# J P Chick & Partners Ltd

04 June 2024

Ref: IE23/006/LLFA resp 2

# LEAD LOCAL FLOOD AUTHORITY QUERIES IN RELATION TO DRAINAGE STRATEGY TRAVELODGE DRURY LANE, LONDON

1 Year

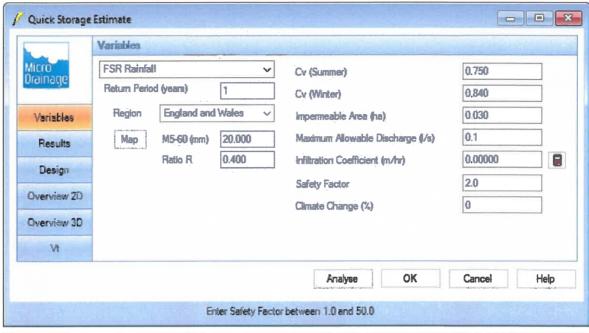
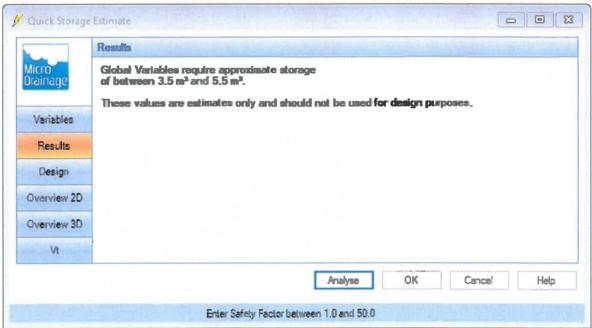
This has been covered within our response to question 1 above.
- 2. Details, via supporting calculations, the greenfield runoff rates for the 1 in 1yr, 1 in 30yr, 1 in 100yr and 1 in 100yr+CC return periods.

This has been covered within our response to question 2 above.
- 3. Details, via supporting calculations, the proposed run off rates for the 1 in 1yr, 1 in 30yr, 1 in 100yr and 1 in 100yr+CC return periods.

- Following the officer's request, we have extended this calculation to accommodate all the return periods, including the 1 in 100yr+CC. A copy of these calculations is appended to this correspondence.
